OJAI UNIFIED SCHOOL DISTRICT

BID ADDENDUM NO. 3 ISSUED 4/18/2019

LIBRARY REMODEL AT NORDHOFF HIGH SCHOOL PROJECT NO. 2018-1714

ADDENDUM NO. 3

LP-0.01

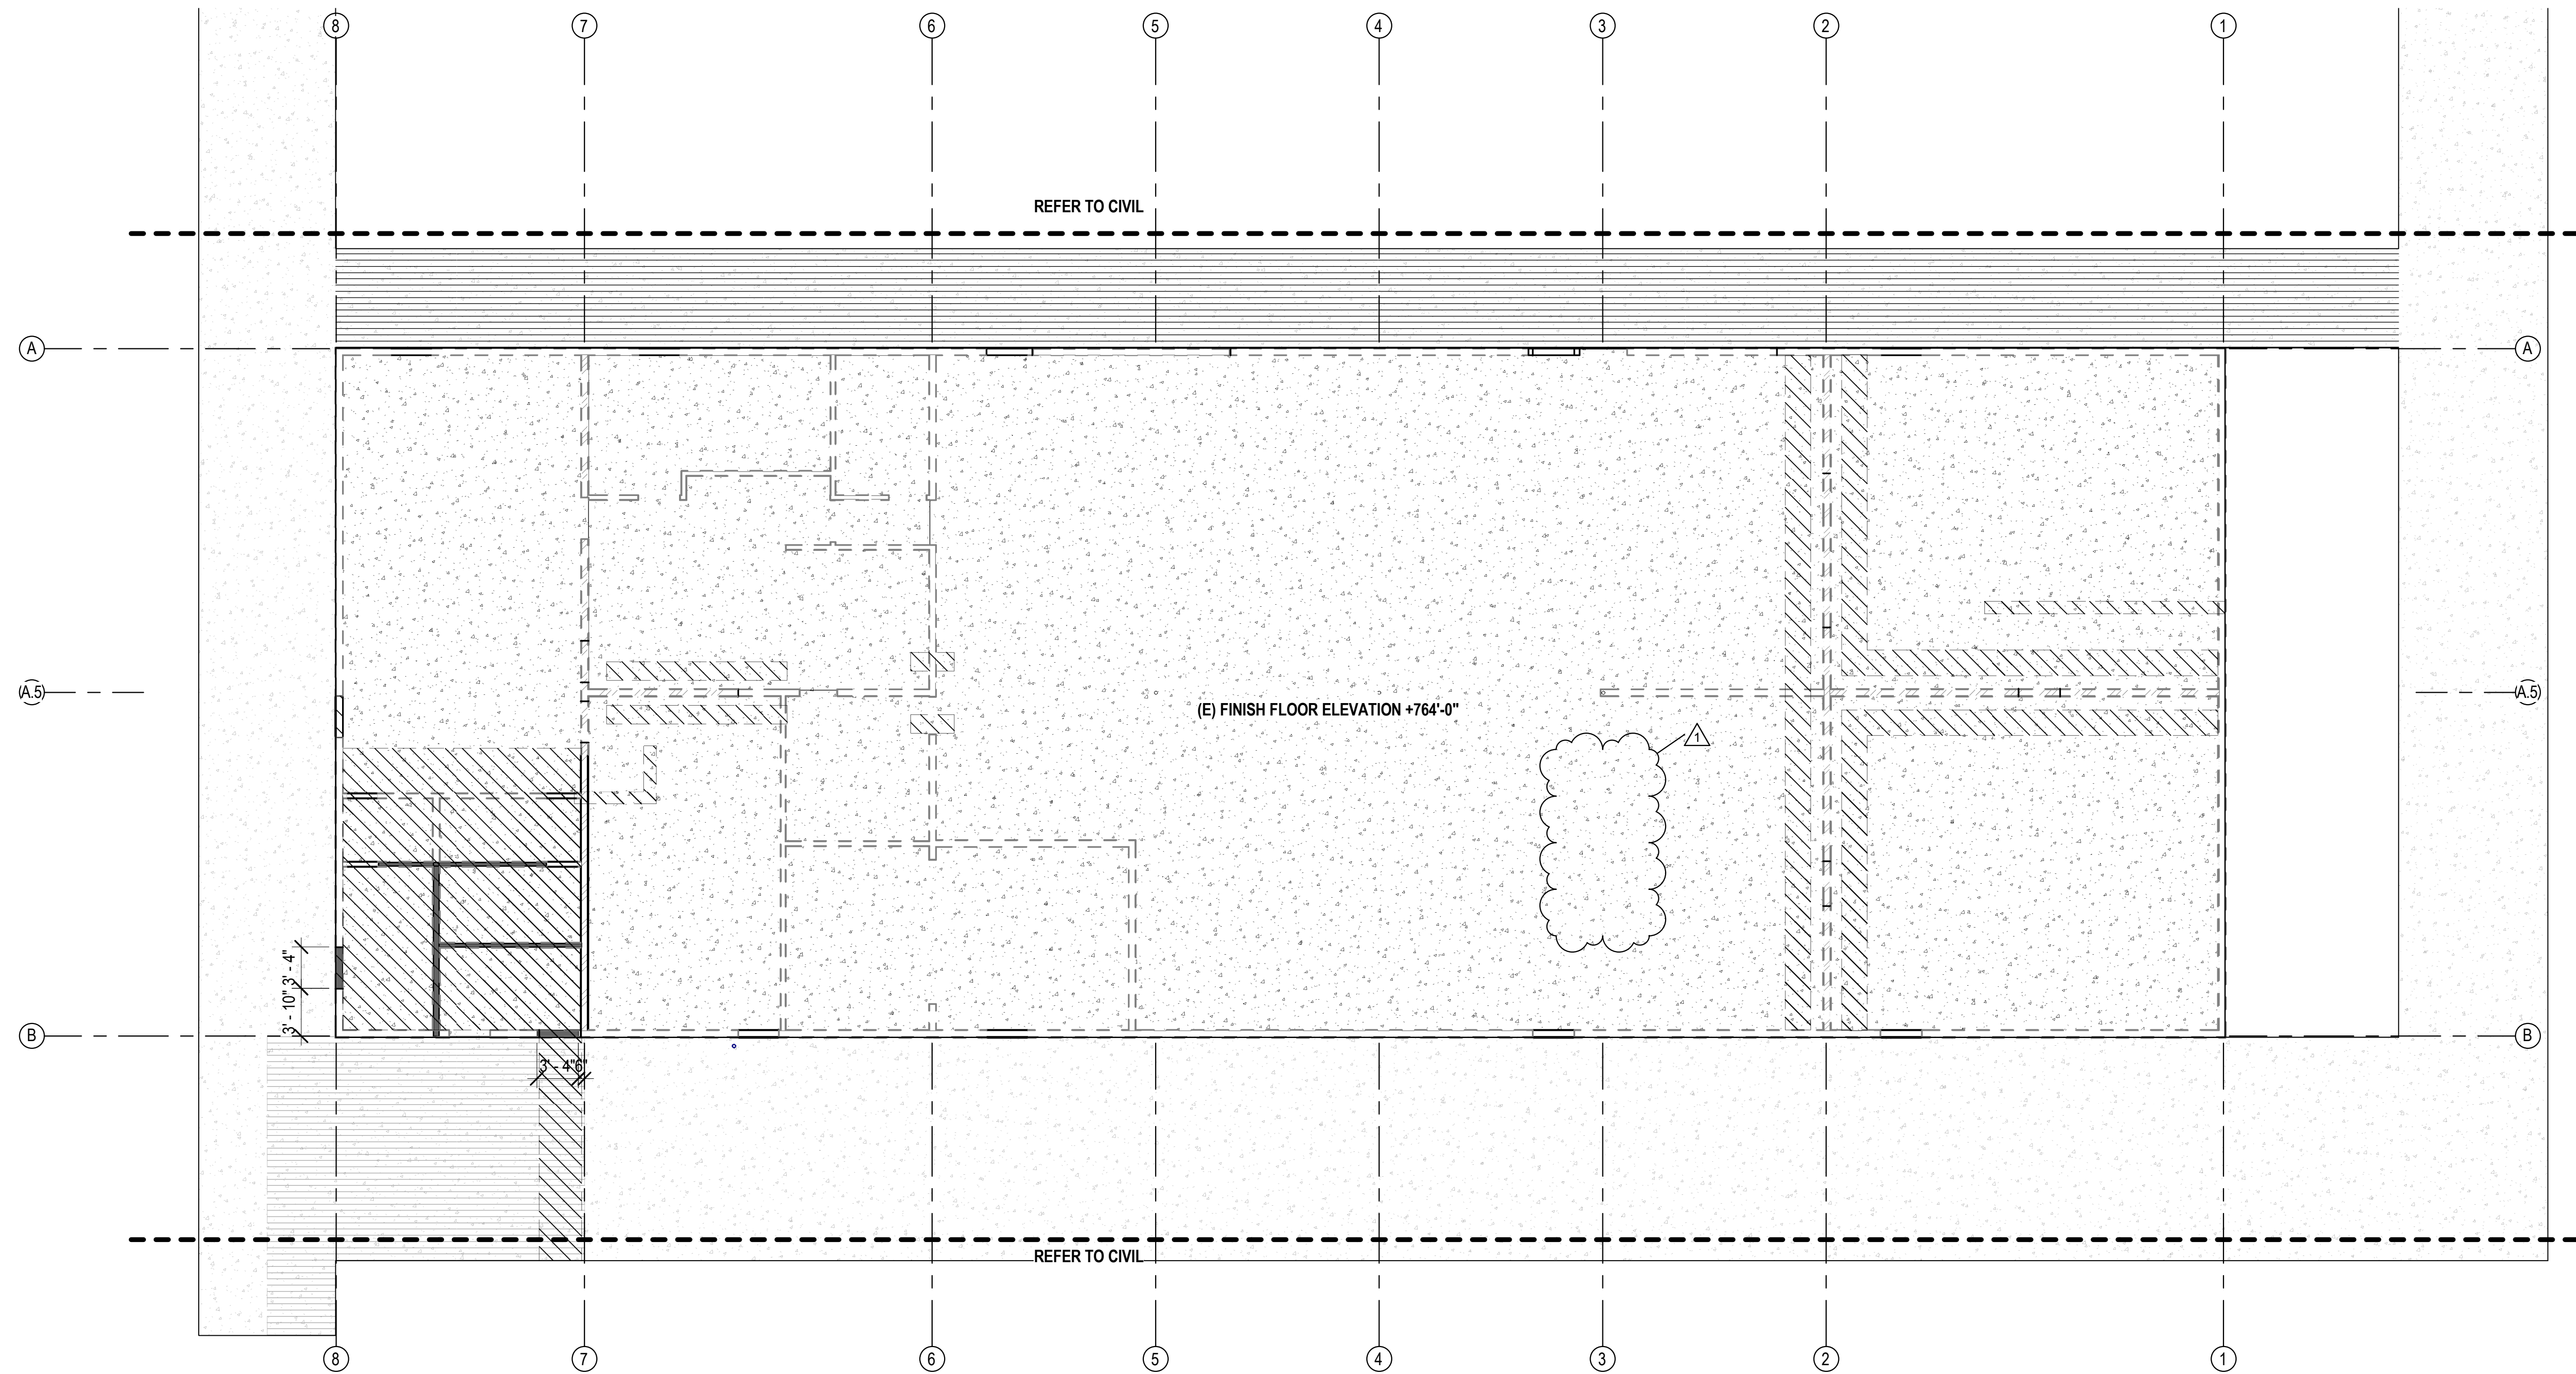
- Item 2 **General turf repair** – Drawings revised to incorporate direction for repair to planting and irrigation.
 LP-0.01 Planting Notes
 LI-0.01 Irrigation Notes
- Item 3 **Stucco** – Drawings revised to clarify scope of exterior stucco.
 A-101 Floor Plan
 A-201 Exterior elevations
- Item 4 **Slab Demolition** – A-004 Demolition Slab Plan revised to coordinate with Floor Plan. An area of slab demolition has been removed from the scope.

1. EXISTING TURF AREAS DISTURBED BY GRADING OPERATIONS ARE TO BE RE-PLANTED IN KIND TO MATCH THE EXISTING CONDITION. DISTURBED AREAS ARE TO BE PREPPED FOR PLANTING PER THESE PLANTING NOTES AND THE PROJECT SPECIFICATIONS. TURF SEED TO BE PER PLANTING LEGEND THIS SHEET. SQUARE FOOTAGE OF NEW TURF SEED AS INCLUDED IN THE PLANT SCHEDULE ON THIS SHEET IS FOR THE AREAS SHOWN ON LP-1.01 ONLY. SEE CIVIL PLANS FOR EXTENTS OF DISTURBED AREA DUE TO GRADING OPERATIONS.

1 FLOOR PLAN
1/8" = 1'-0"

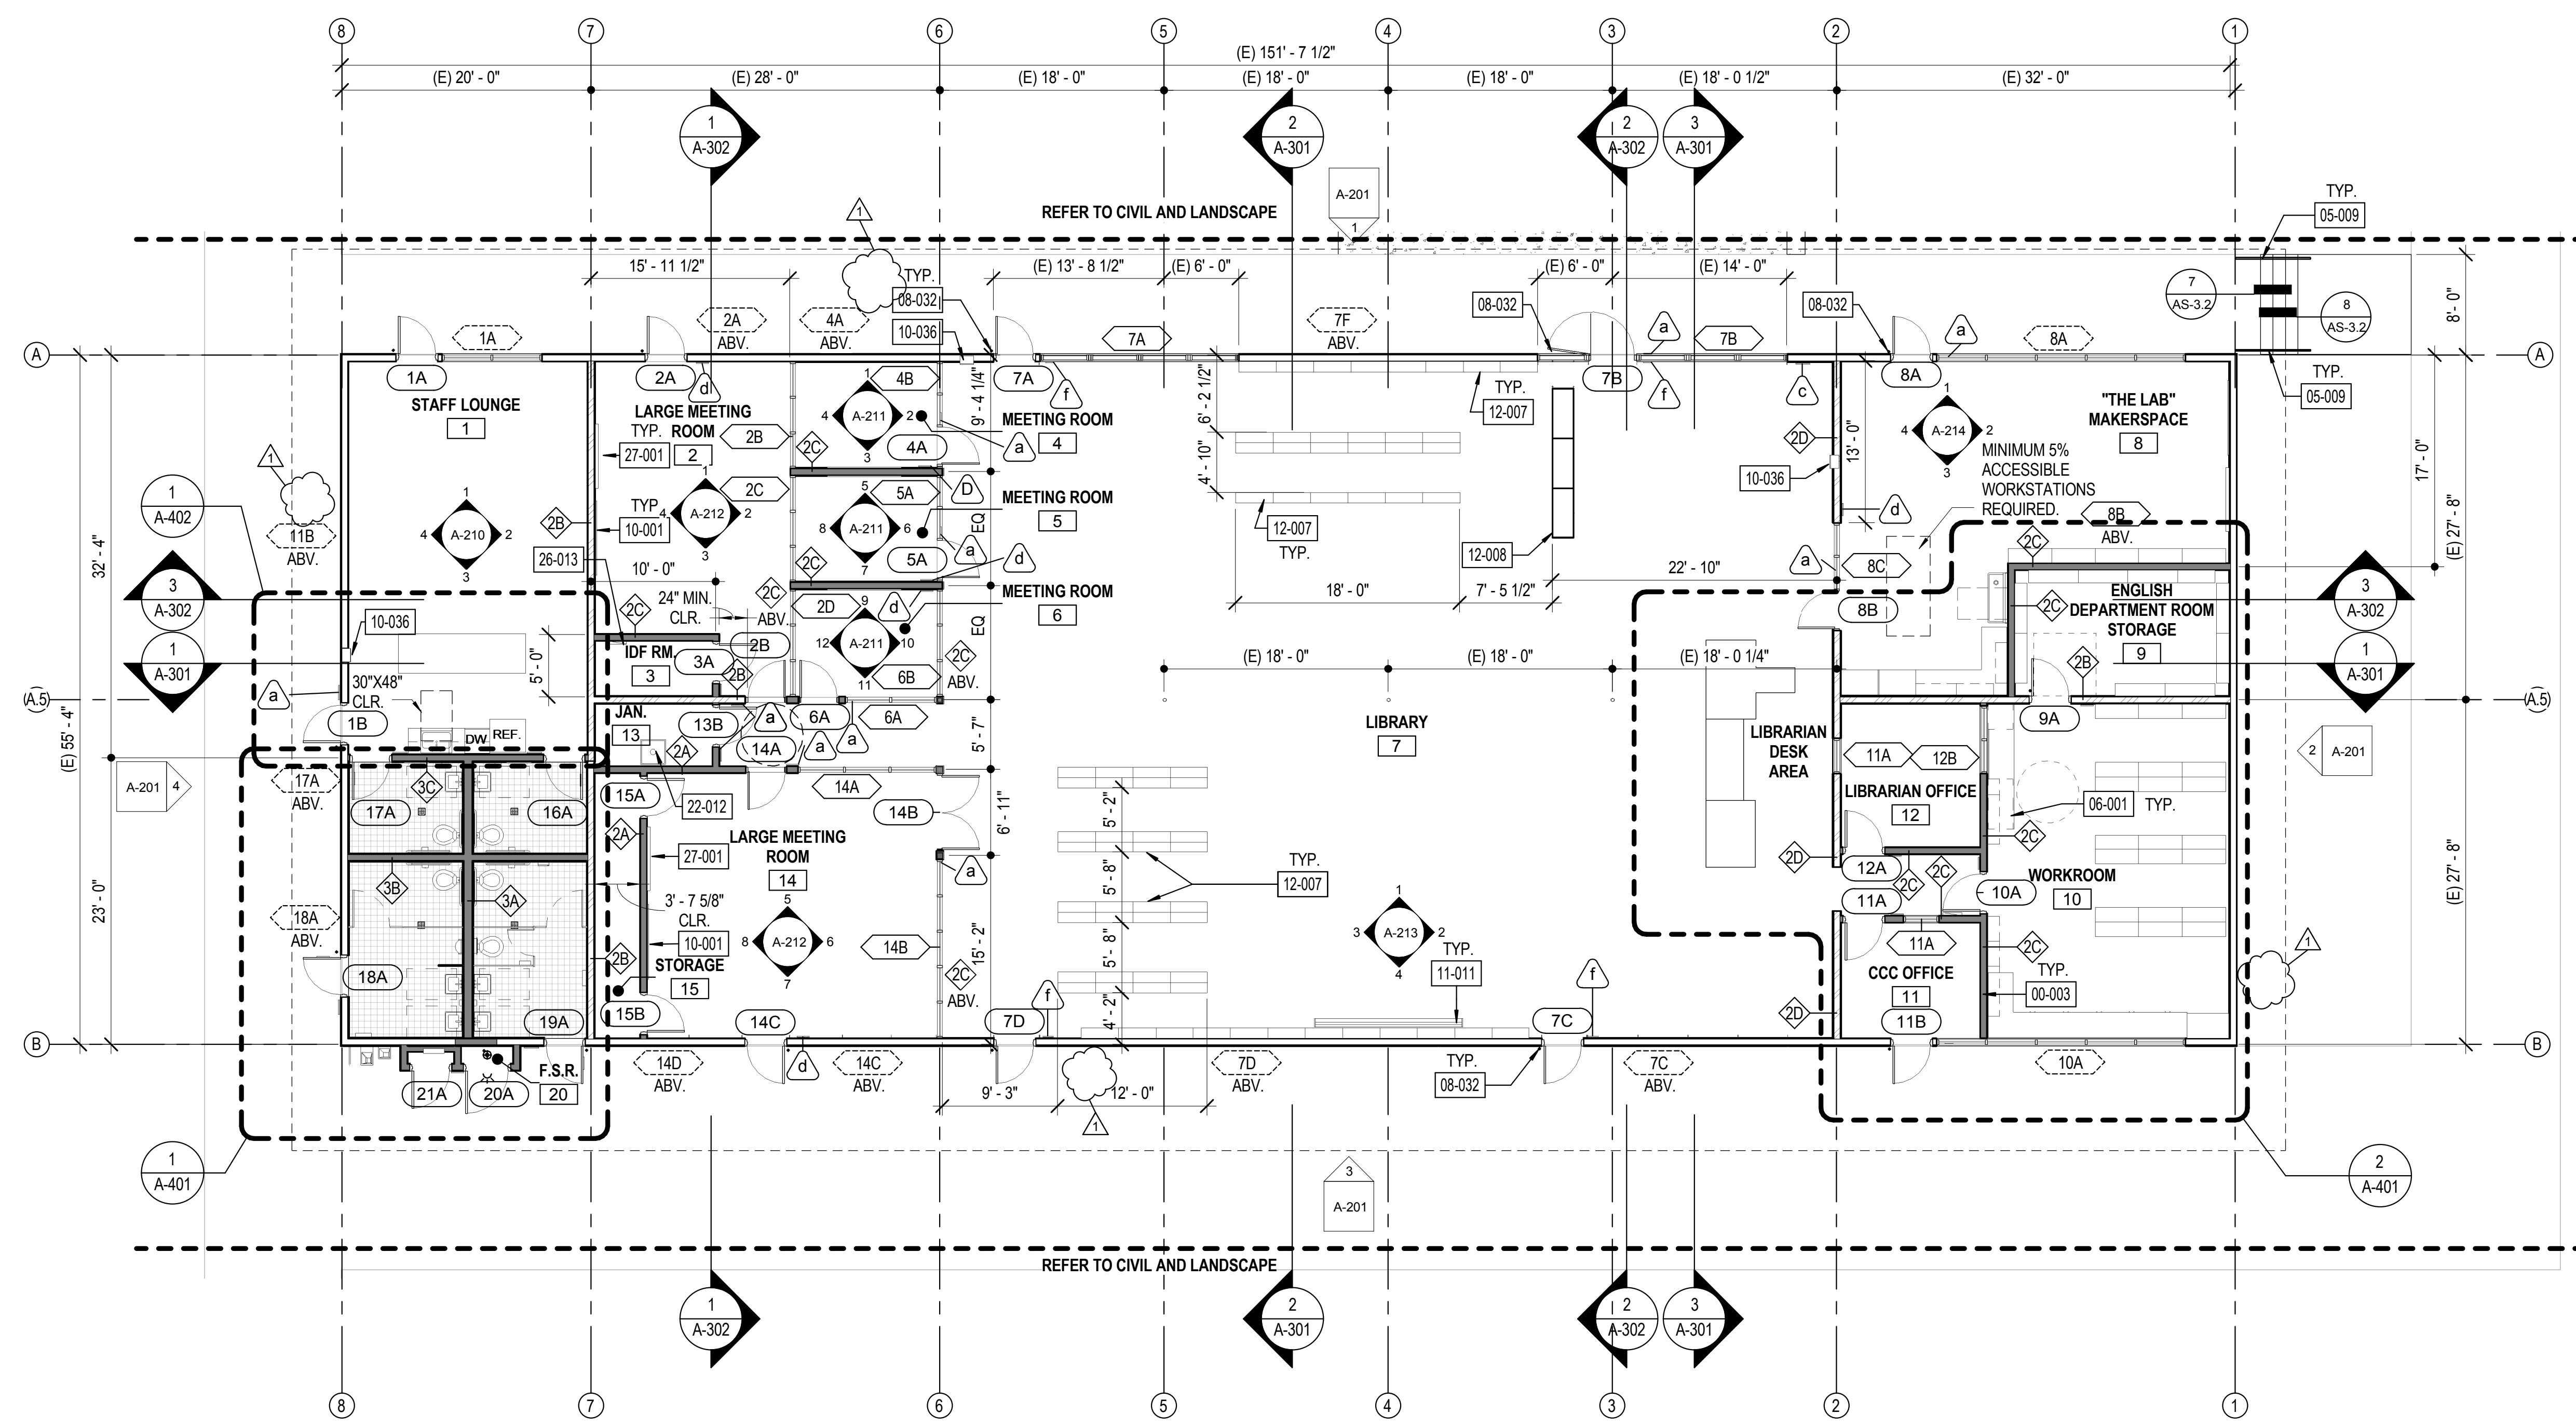
7	<p>Which form does page 47 in the Project Manual belong to?</p>	<p>Please restate question.</p>	<p>District</p>
8	<p>The plans are not clear on where new plaster goes and where existing plaster to remain is.</p> <p>1) The floor plan, A-101, indicates Wall Type 1A for the south, west and east</p>	<p>All existing plaster not required to be modified by construction activity is to be protected in place and painted.</p> <p>1) Wall type 1A removed from</p>	<p>RNT</p>

exterior walls, but has no wall type indicated for the north wall. Wall Type 1A on AD-101 indicates 7/8" Exterior Plaster O/ 1/2" sheathing. Based on this info the plans call for new plaster over new sheathing at the south, west & east exterior walls only.

existing walls in floor plan A-101 for clarity.

1 NORTH ELEVATION
1/8" = 1'-0"

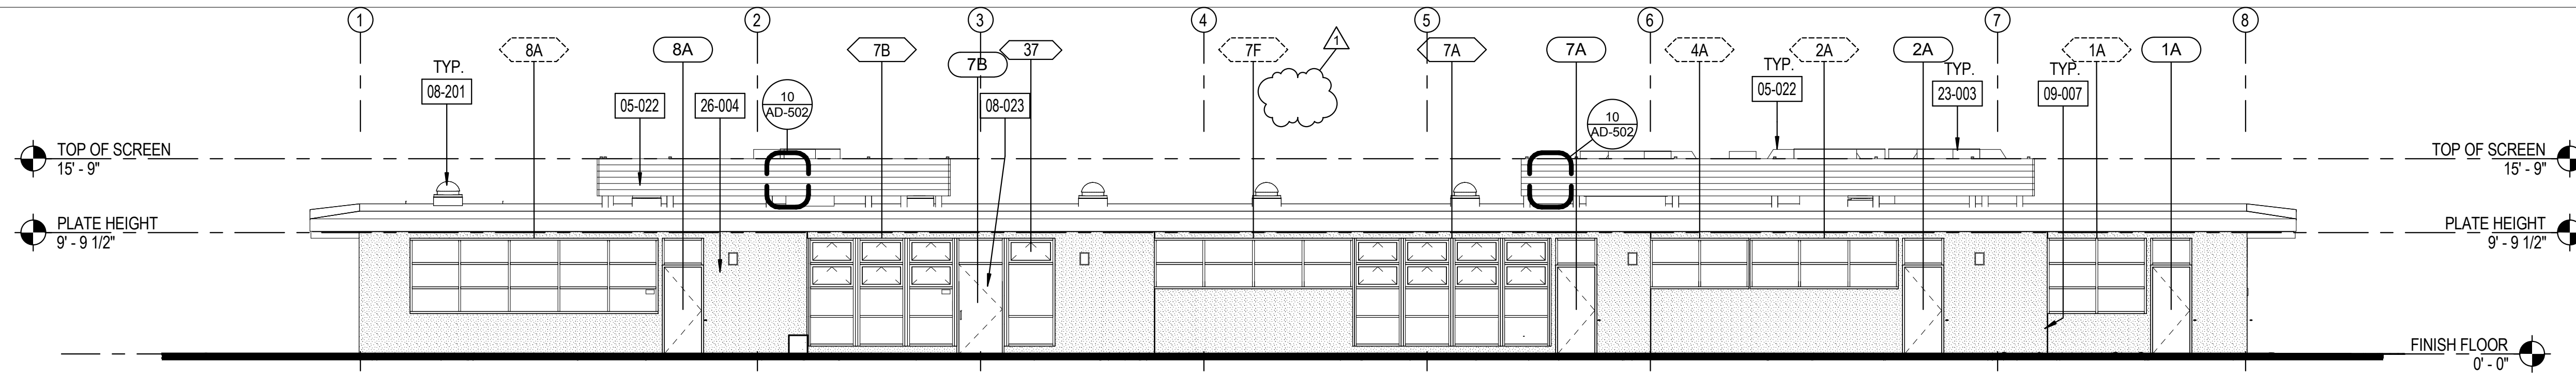
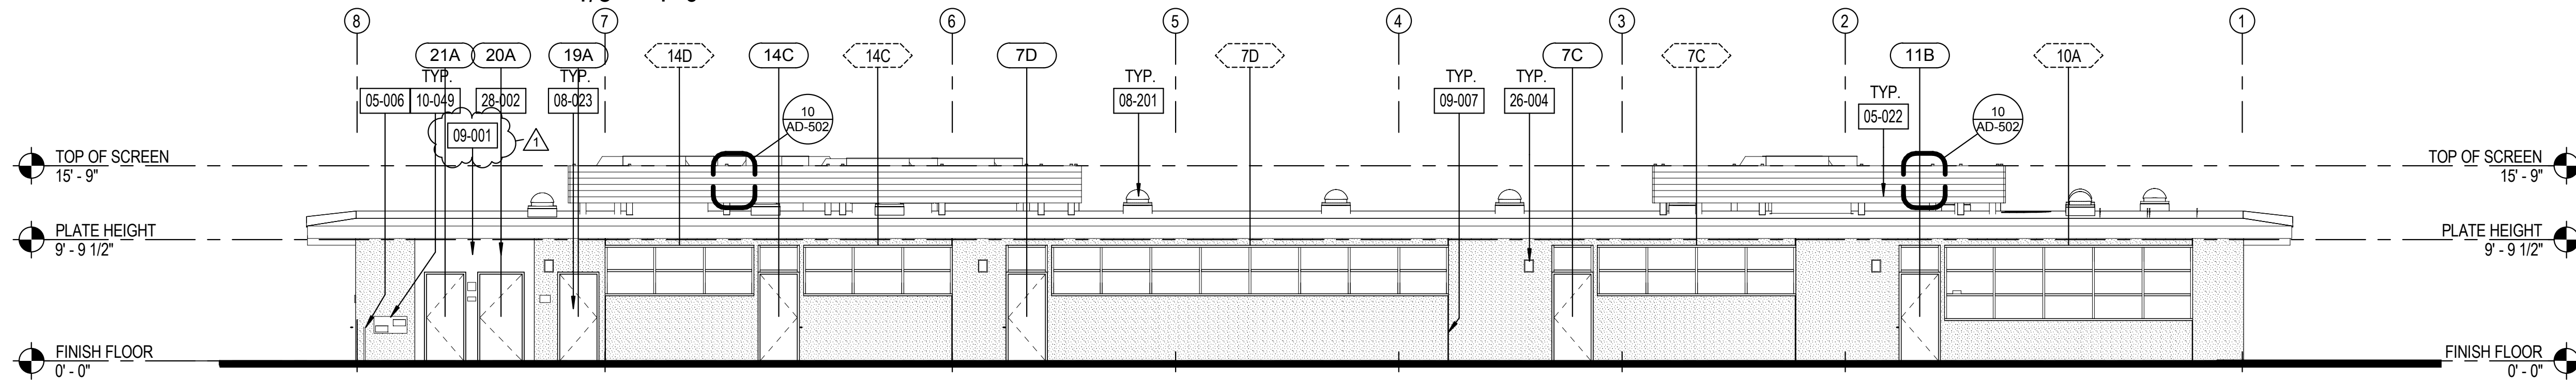
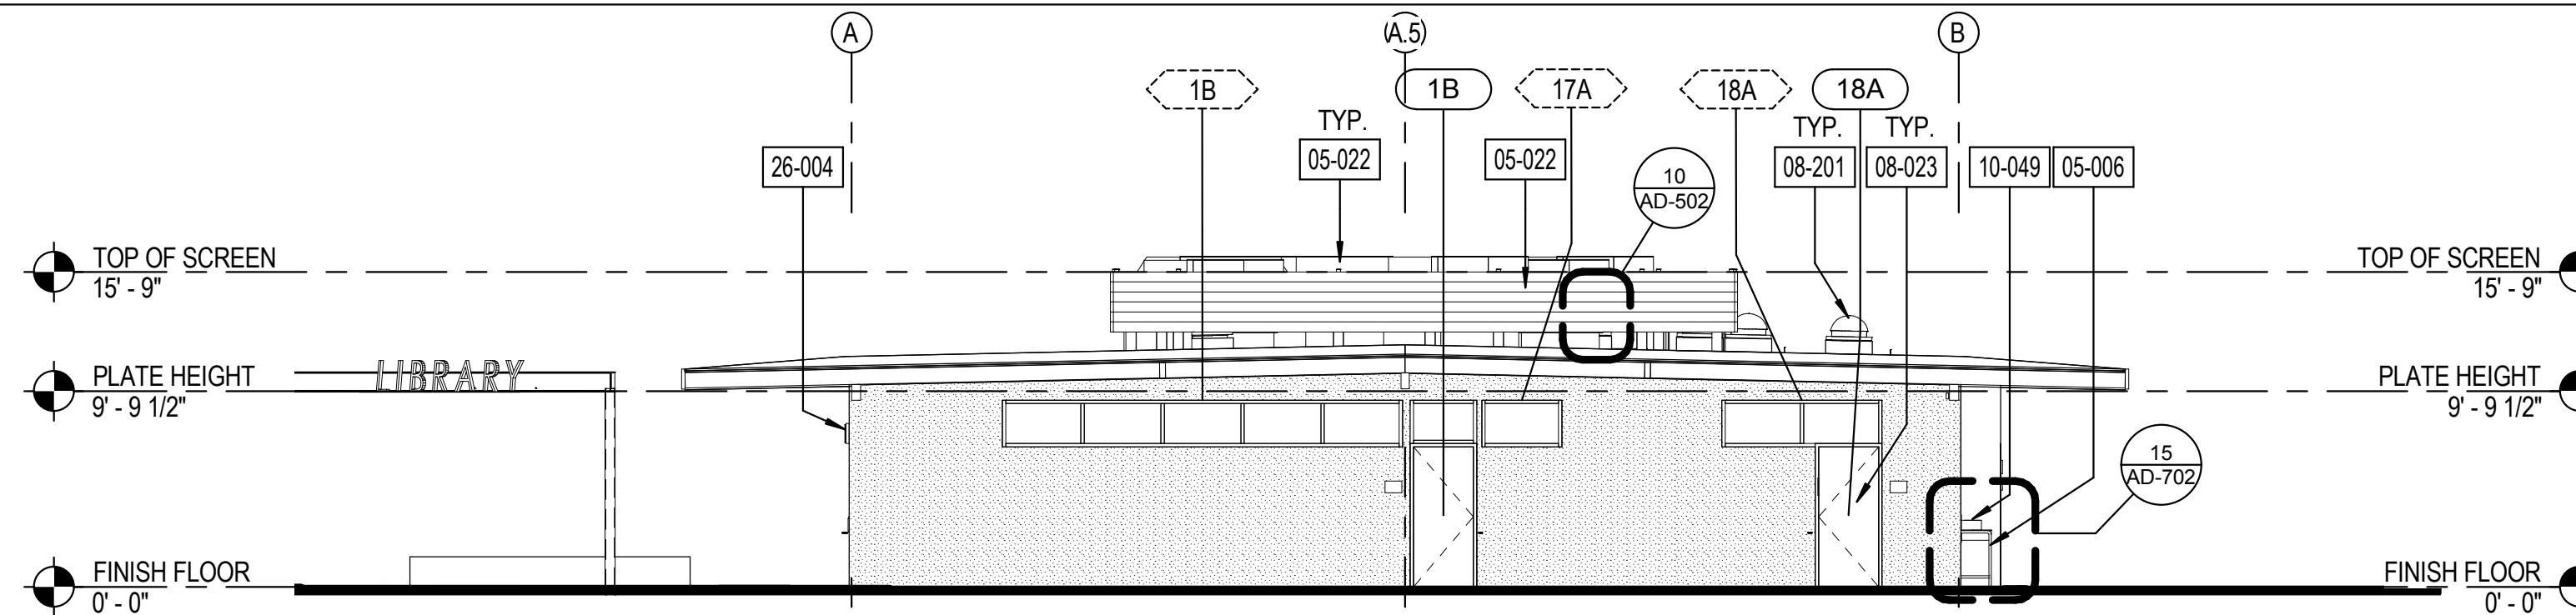
3) Keynote 09-001 on A-201 notes Exterior Cement Plaster, indicating new plaster. This Keynote is indicated on the north & east elevations as typical, however as noted in #2 above only the east elevation is indicated to get new plaster, based on the graphic designation in the legend. Please clarify which exterior walls get a) new sheathing and b) new cement plaster.

- 2) East elevation now shows (E) stucco.
- 3) Keynote 09-001 removed from existing plaster. Applied to new plaster only.
